**SUNDRY NOTICES AND REPORTS ON WELLS**  
*Do not use this form for proposals to drill or to re-enter an abandoned well. Use form 3160-3 (APD) for such proposals.*

8. Well Name and No.  
HEIGHT CC 6\_7 FEDERAL COM 33H

OXY USA Inc. respectfully requests to amend the casing/cementing program for the following wells. The four wells will have a similar design and the specific details are for the 33H.

General well schematic:

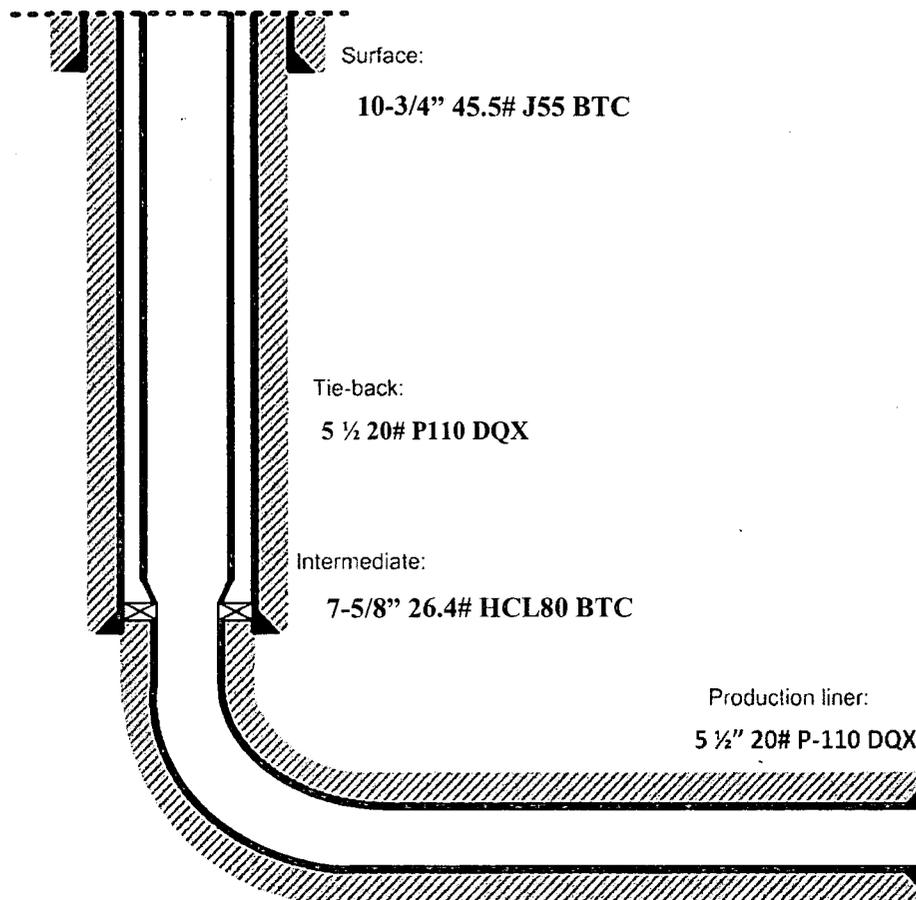
- Drill 14-3/4" hole x 10-3/4" casing for surface section. Cement to surface.
- Drill 9-7/8" hole x 7-5/8" casing for intermediate section. Cement to surface.
- Drill 6-3/4" hole x 5-1/2" liner for production section. Cement to top of liner, 100' inside 7-5/8" shoe.
- Release drilling rig from location.
- Move in workover rig and run a 5-1/2" 20# P110 DQX tie-back frack string and seal assembly (see connection specs below). Tie into liner hanger Polished Bore Receptacle (PBR) with seal assembly.
- Pump hydraulic fracture job.
- Flowback and produce well.

When a decision is made to develop a secondary bench from this wellbore, a workover rig will be moved to location. The workover rig will then retrieve the tie-back frack string and seal assembly before temporarily abandoning the initial lateral.
